DATE July 1, 2014
TO Jim Knott, Roadway Design Engineer
FROM Joel Rossman, Assistant State Bridge Engineer
THRU Mark Traynowicz, State Bridge Engineer
SUBJECT Niobrara East and West
Project No. S-12-5(1011), CN 31674
Bridge Engineering Review

This memorandum summarizes the results of a bridge engineering review of proposed bridges on the alternative alignments under consideration for the Niobrara East and West reconstruction project.

Subject: Summary Report of Proposed Slide Mitigation for Alternative B1
Niobrara East & West 12-5(1011), CN 31674

EXHIBIT A

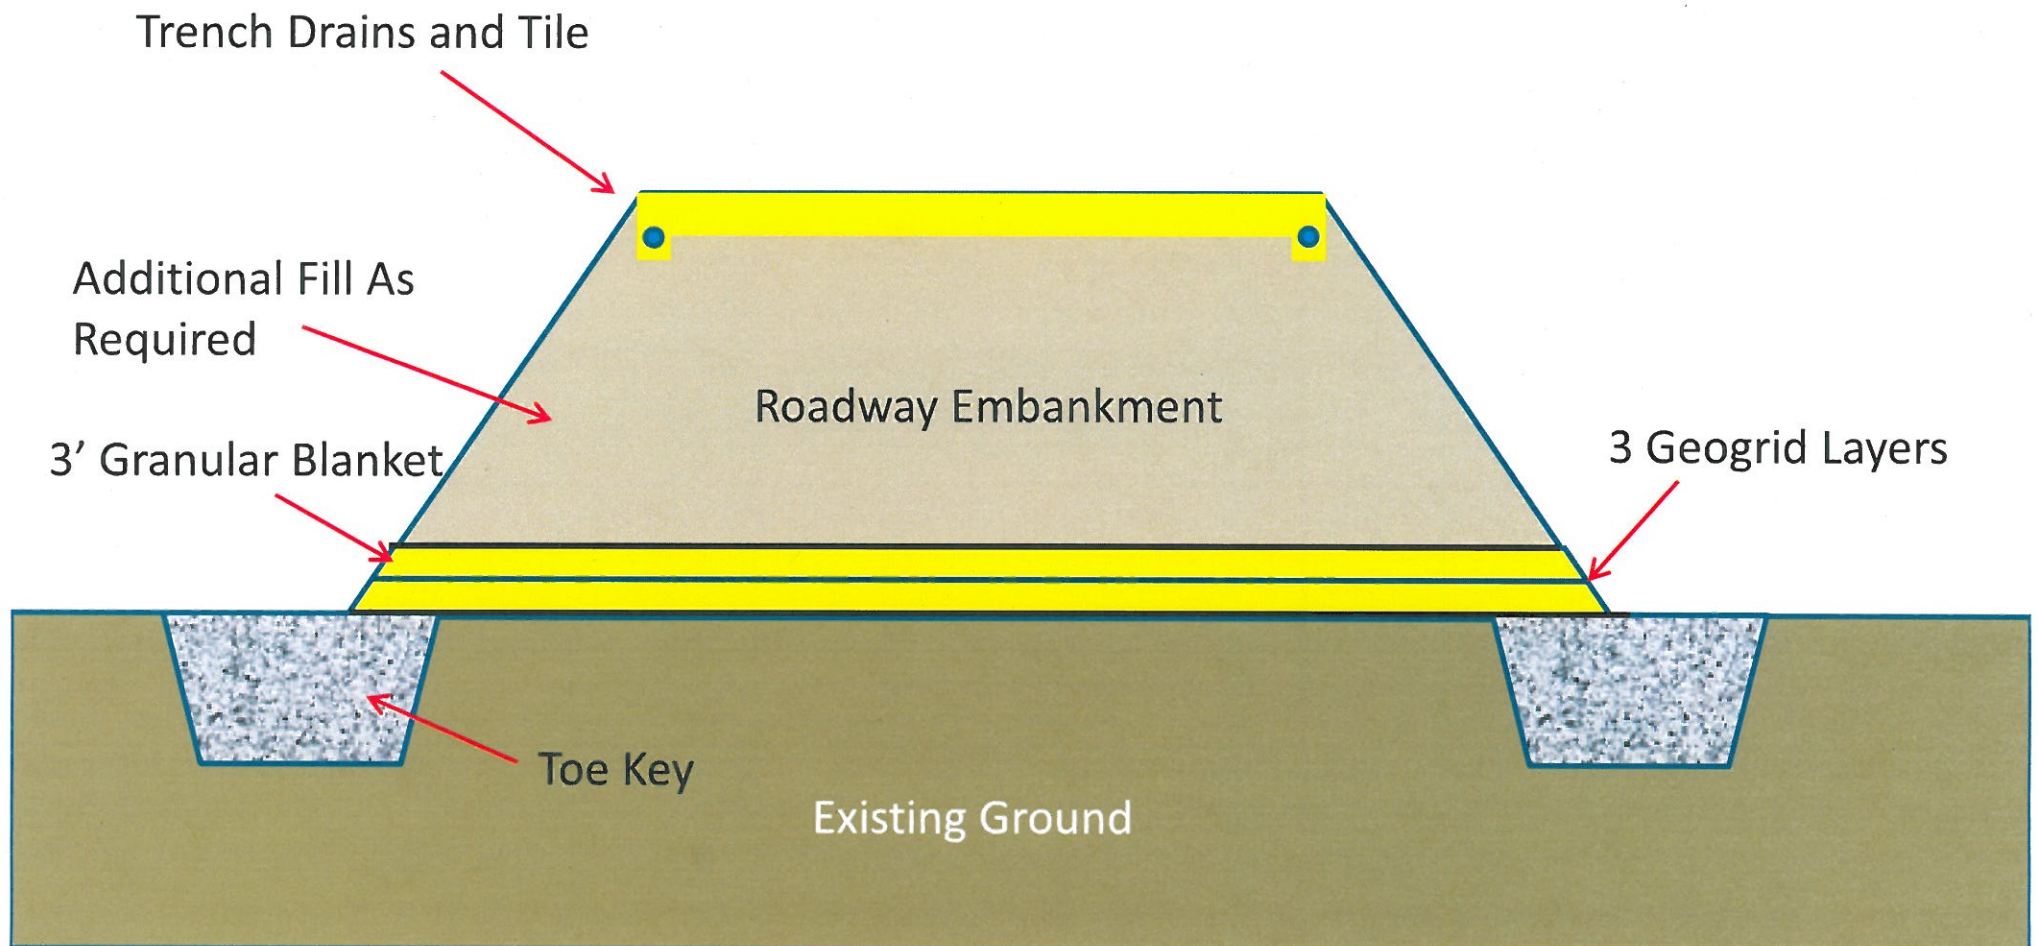
A Typical Fill Section (see Exhibit A) will require a minimum of 3' of granular fill with 3 layers of geogrid. If the proposed grade is only 1' above the existing grade, this area will require additional 2' of over-excavation in order to place the required 3' of granular material. Toe keys will need to be placed at the bottom of the foreslopes and standard trench underdrains will also be required. Additional fill (above the 3' minimum granular fill) required to meet the vertical profile can be any material, but due to concerns with the availability of suitable material, this too will most likely be granular material.

EXHIBIT B

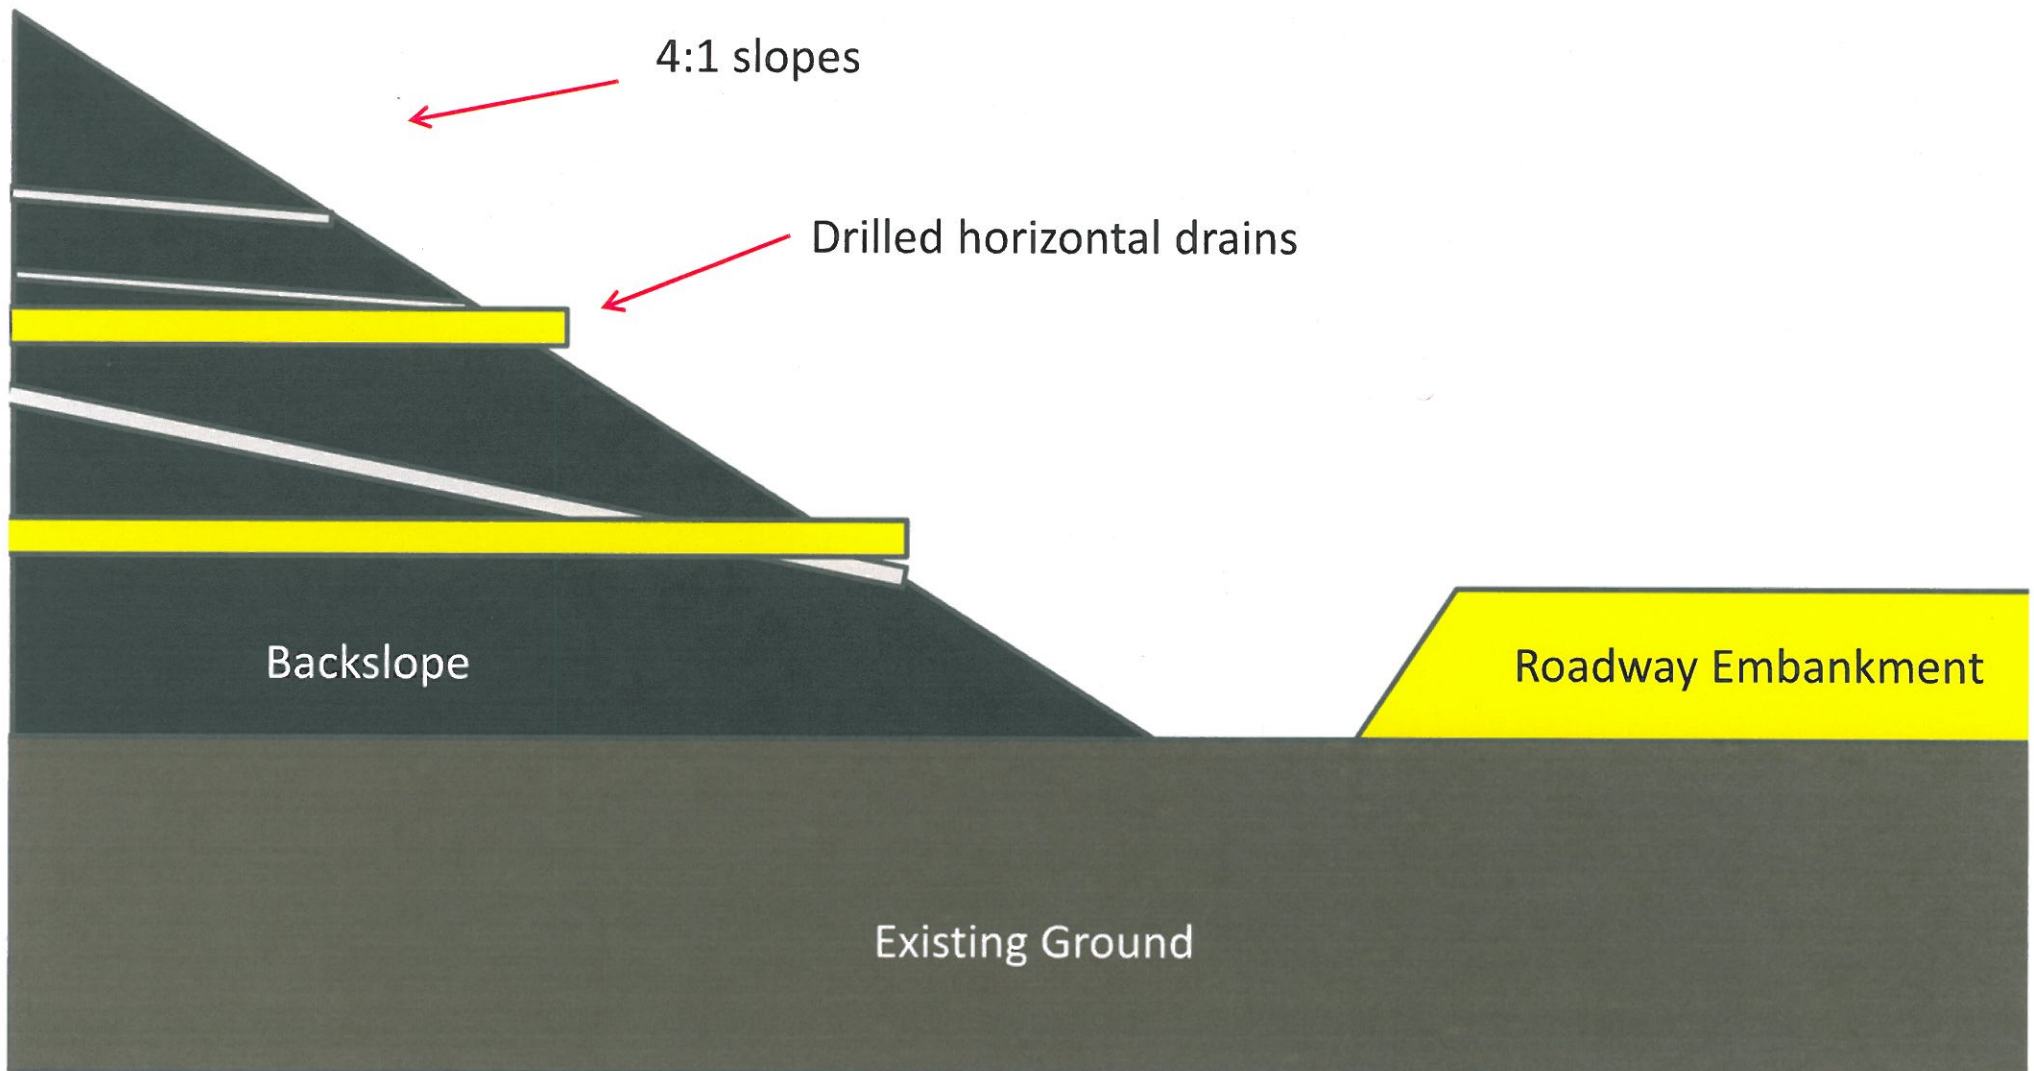
A Typical Cut Section (see Exhibit B) will have the roadway placed on 3' of granular fill with 3 layers of geogrid; this will require 3' of over-excavation to allow for placement of this granular material. Backslopes will need to be flatter than 4:1's to prevent slides and will require a network of horizontally drilled drains to attempt to dewater the shale and prevent future slides. The horizontal drains are installed in a grid pattern with horizontal and vertical spacing varying from 25'-50' and are installed at an angle of 2°-5°. The length of these drains is dictated by the depth of the cut and the location of the pipe. For example, in a 30' cut section, the pipe at the bottom of the ditch will need to be 30' long. These drains are then connected together with a collection system to prevent the water collected from flowing down the backslopes or ditch. This collection system will then need to be outletted into cross-culverts to allow the water to flow away from the roadway. These drains have an average cost of \$30-40/ft and will require

maintenance approximately every 8 years to clean out any collected sediment present in the drains. This will require additional property rights for the entire length of the pipe and access to each level of the drains.

EXHIBIT C

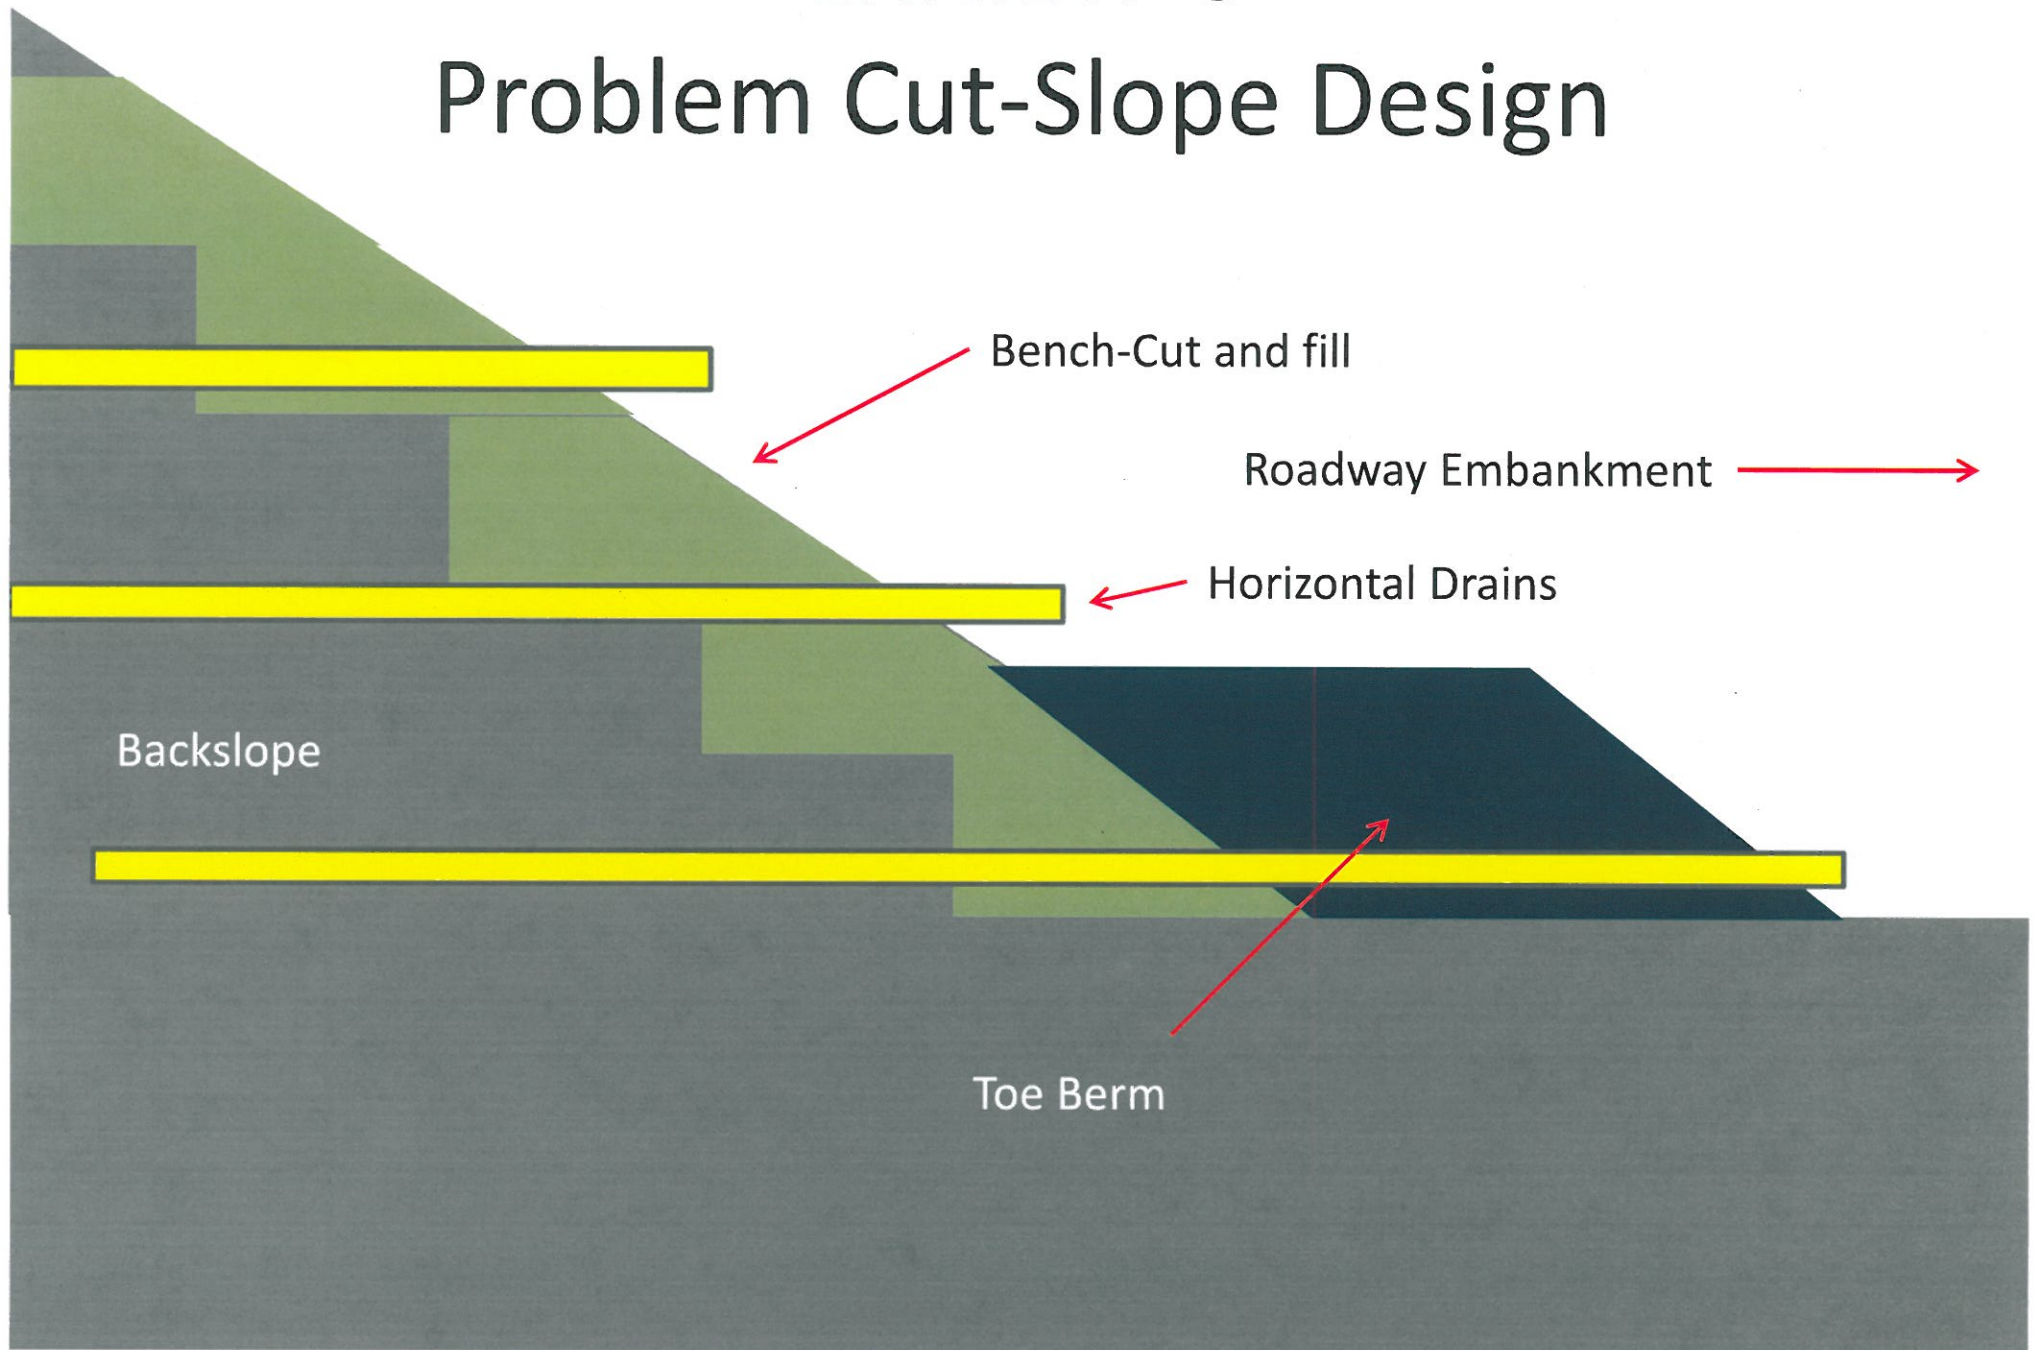
A Problem Cut Section (see Exhibit C) will have all of the same elements of the Typical Cut Section above with the addition of bench cutting the backslope and the placement of toe berms. The bench cuts will require the placement of cohesive soils to stabilize the slopes and prevent additional slides. Then toe berms will need to be placed at the bottom of the backslope to prevent future slippage. Toe berms are normally constructed out of Rip-Rap and are typically 15' wide and 10' tall but will need to be designed on a case by case basis. These berms will be placed in the roadside ditches and as a result, these ditches will need to be widened to accommodate this additional width.

Figure 1. Cut-slope Mitigation Techniques

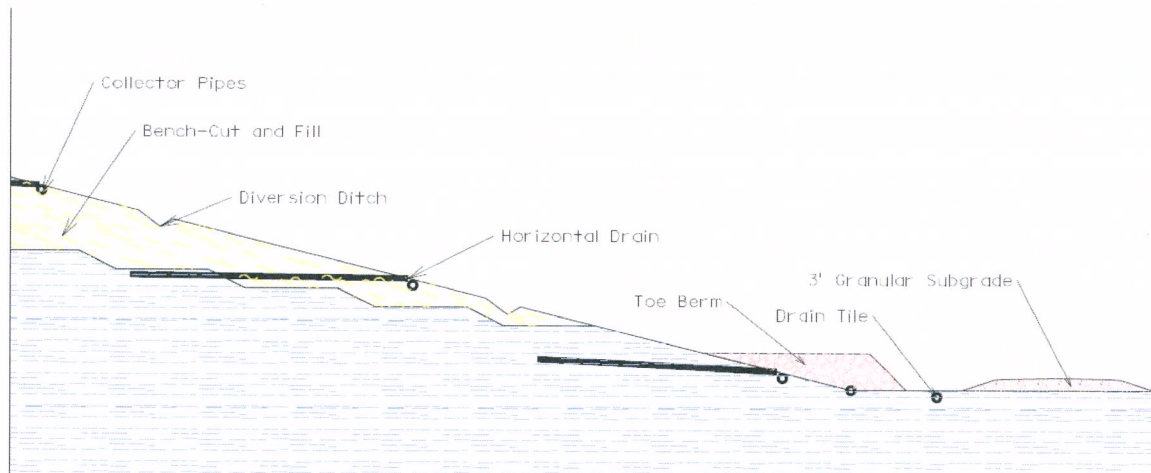
Each cut-section should be evaluated on a case by case basis after a thorough subsurface investigation, laboratory testing, and analysis. The information provided are minimum recommendations based on observations in the field. Additional mitigation techniques may be warranted after a thorough drilling and testing program has been performed. Figure 1 shows a graphical presentation of the possible cut-slope mitigation measures.

- All slopes in cut-sections shall be constructed at 4H:1V.
- Drilled horizontal drains shall be installed at a horizontal and vertical spacing of 25'. The minimum length of the drains should be equal to the vertical distance from the toe of the cut-slope to the top of the cut section. Example: drains installed in a 50' cut-section should have a horizontal length of 50'. The drains are installed at a 2° to 5° inclination to allow for the gravitational flow of the groundwater. The approximate cost is \$30-\$40/ft.

- Beneath the roadway section a minimum of 3' of granular material will be required. This will require over-excavation and replacement with granular materials in cut-sections that bottom out in shale or other cohesive materials.

- Bench-cutting may be required where weathered shale is observed. The cut-slopes will be bench-cut and replaced with low to medium plastic cohesive soils (not the existing shale materials).
